CITY PLANNING COMMISSION

APPLICATION: A. Negative Declaration

- B. Special Permit to develop a 117 unit apartment complex for senior citizens in the Limited Commercial (C-1) Zone.
- C. Variance to reduce the required parking from 184 spaces to 90 spaces.
- D. Lot Line Adjustment to merge two lots.

APPLC. NO. P87-371 MEETING DATE September 24, 1987 ITEM NO 19

SITE PLAN

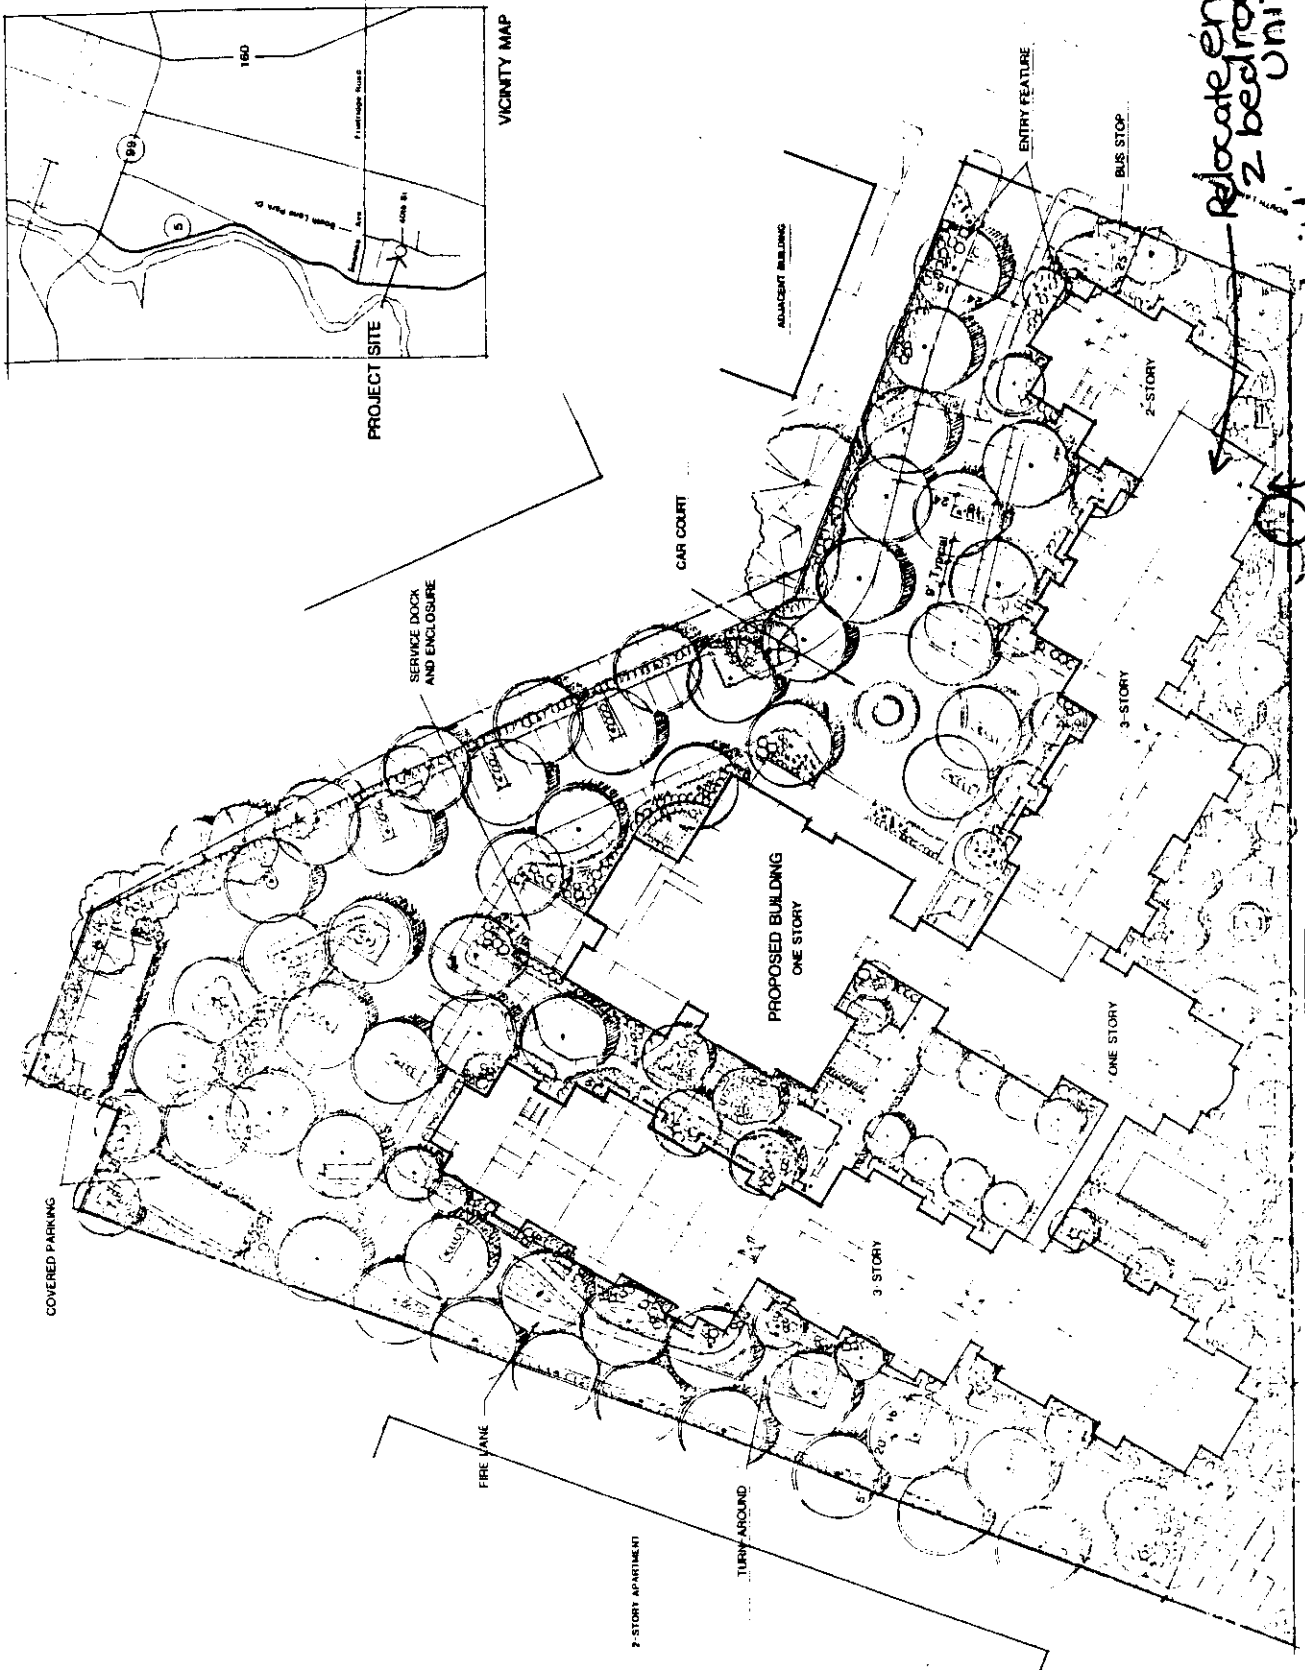
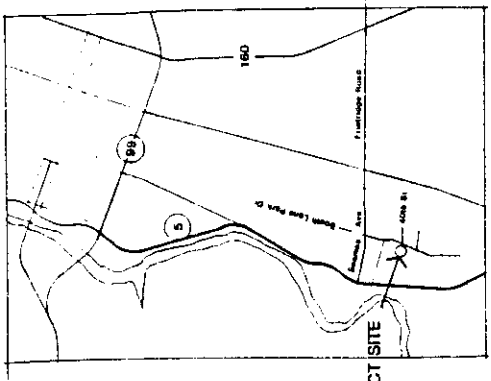
The applicant has designed the apartment complex so that the communal facilities are at the center of the project. Building heights range in size from one story to three stories with a two story structure along the South Land Park Drive frontage and one story structures in the center of the site. Overall, adequate building and landscaped setbacks have been provided; however, along a portion of the south property line an eight foot setback is proposed for one of the three story buildings. To insure greater privacy for both the residents of the existing apartment complex to the south and those of the future senior apartment complex, Planning staff recommends that this building setback be increased to 13 feet by moving the eastern three story building five feet to the north and reducing the height of the building to two stories at the end of the structure. (Exhibit C)

1. Revised plans indicating the relocation of one three story structure five feet to the north and the relocation of the end unit on the third story of the structure shall be submitted for Planning Director's review and approval prior to issuance of building permits. (See Exhibit C)

Relocate end of 2-bedroom unit

Move building

min: 5 ft. to north (13 ft. setback)

LANDSCAPE PLAN

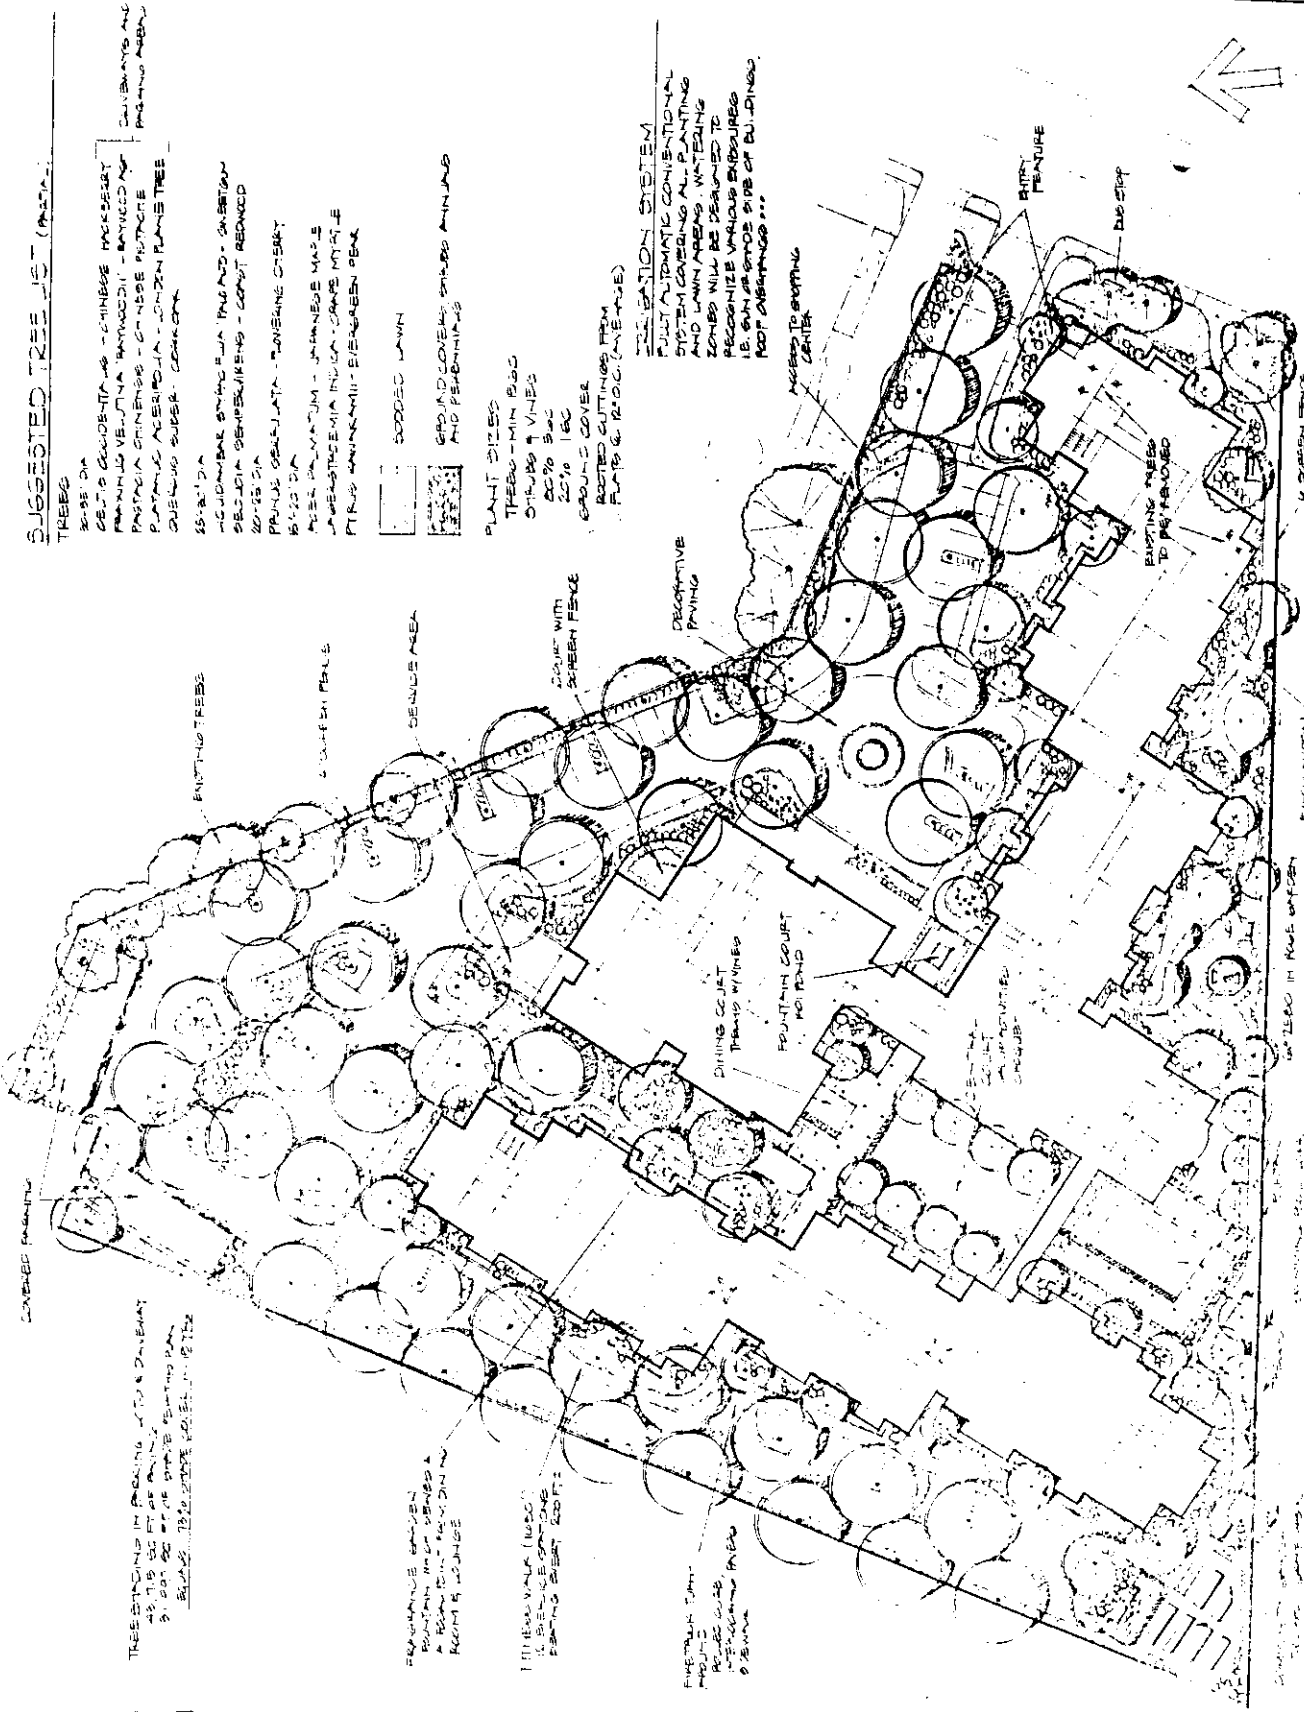
2. Revised landscape, shading and irrigation plans shall be submitted for Planning Director's review and approval prior to issuance of building permits. The applicant shall utilize evergreen trees along the north, south and west property lines, where possible, for screening purposes, excluding the area south and west of the community garden.

3. Proposed building colors and a sample of the proposed roofing material shall be submitted for Planning Director's review and approval prior to issuance of building permits. The revised plans shall continue to indicate the recreational amenities and gardens shown in Exhibit D.
